# **FINAL DRAINAGE PLAN**

## **THE RIDGE AT LORSON RANCH**

**FILING NO. 1: SF 22-004**

**JANUARY, 2022**  
**REV. MARCH, 2022**

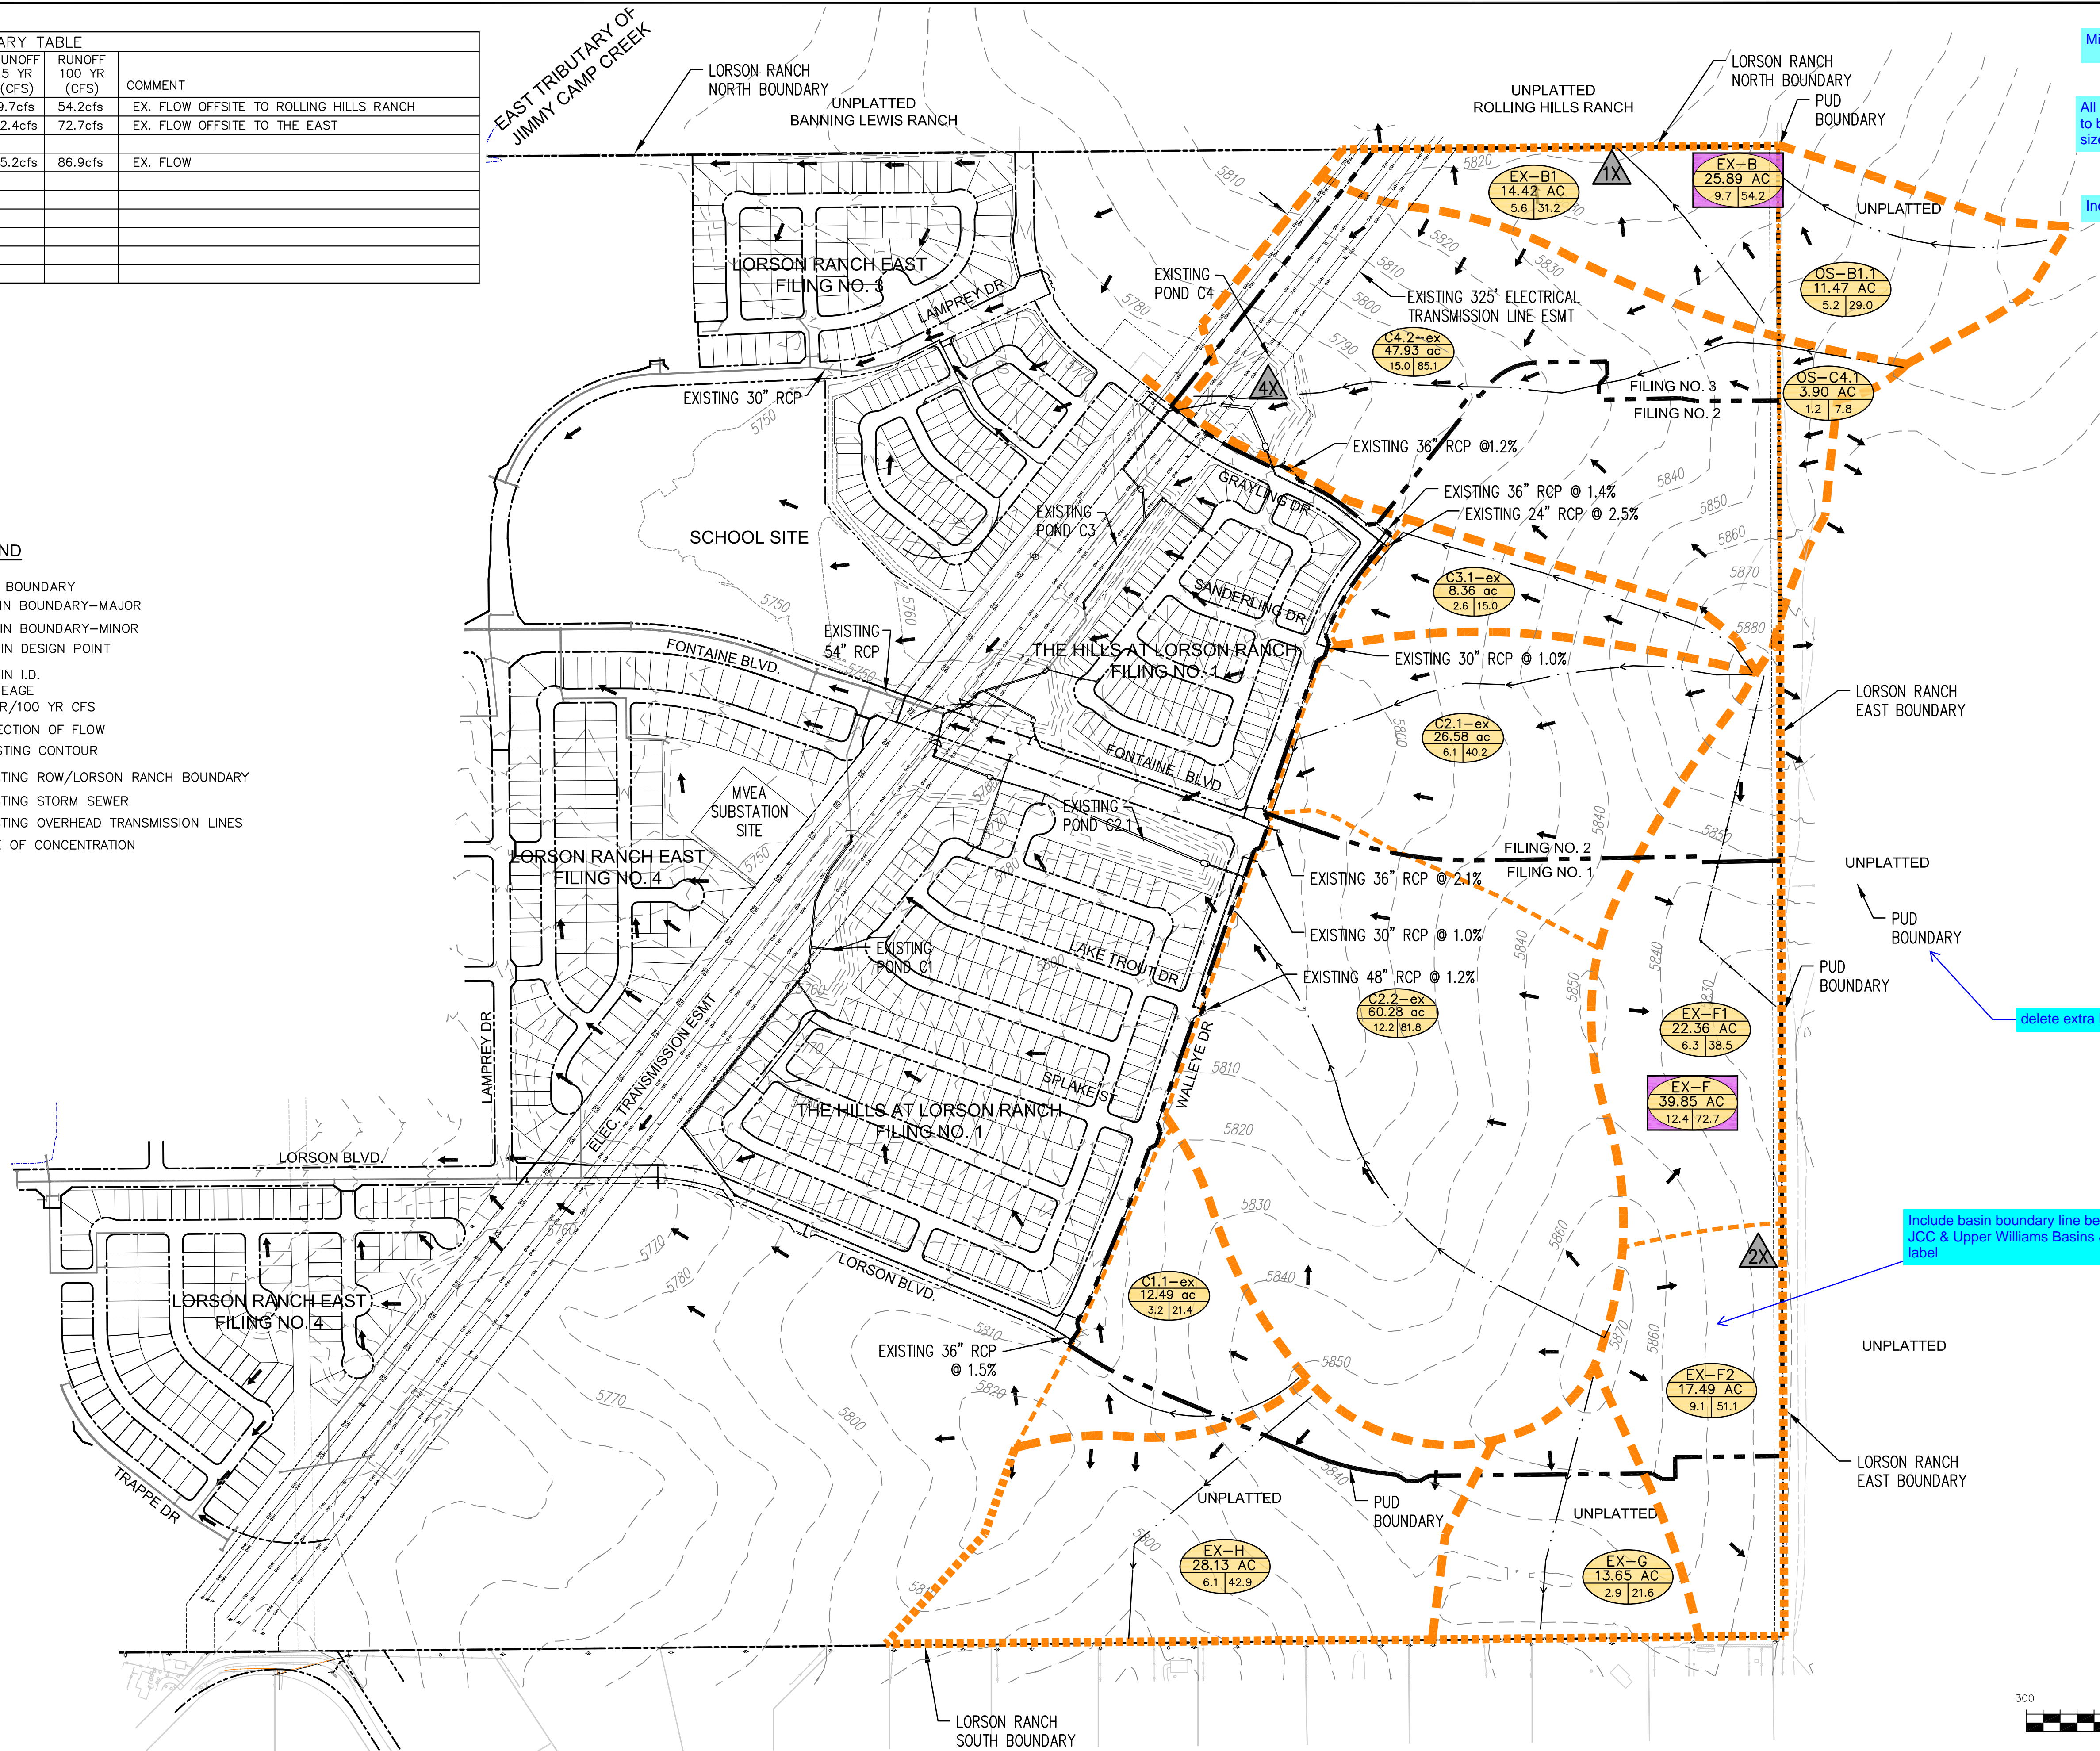
Missing minor contours

delete extra label

DATE: MARCH, 2022  
 PROJECT NO.: 100.064  
 SHEET NUMBER: 5  
 TOTAL SHEETS: 5

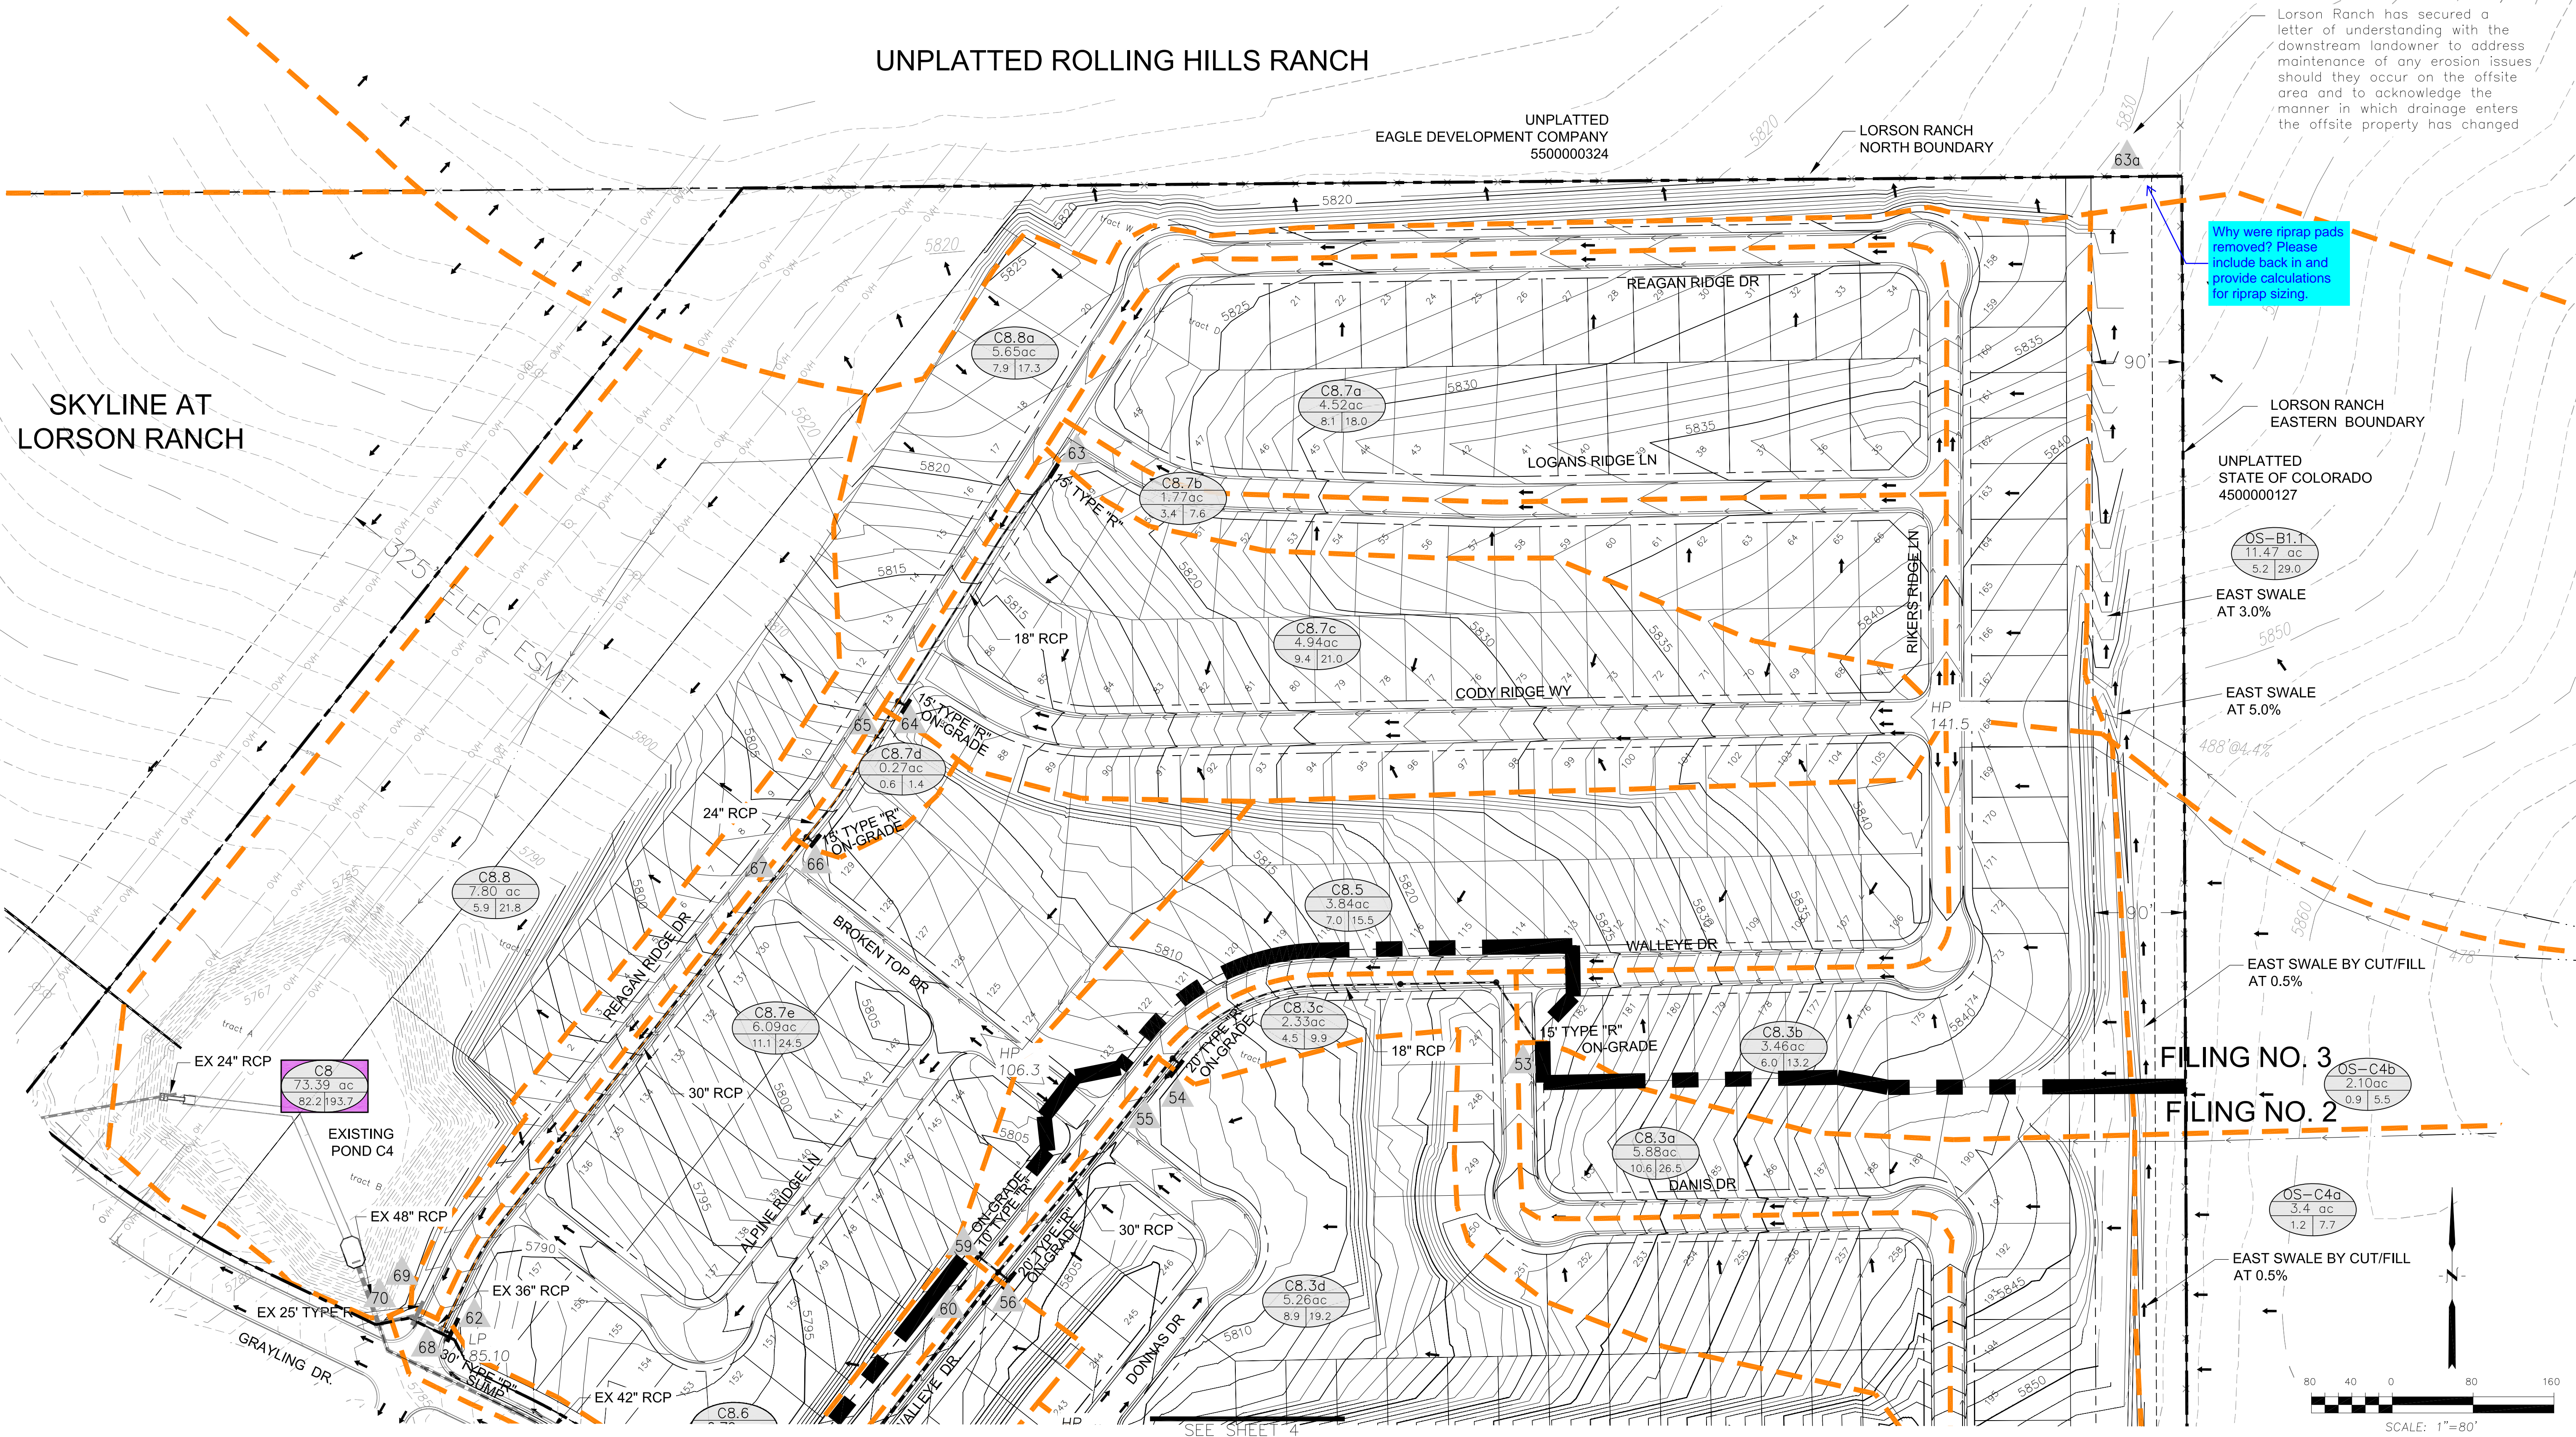
Why were riprap pads removed? Please include back in and provide calculations for riprap sizing.
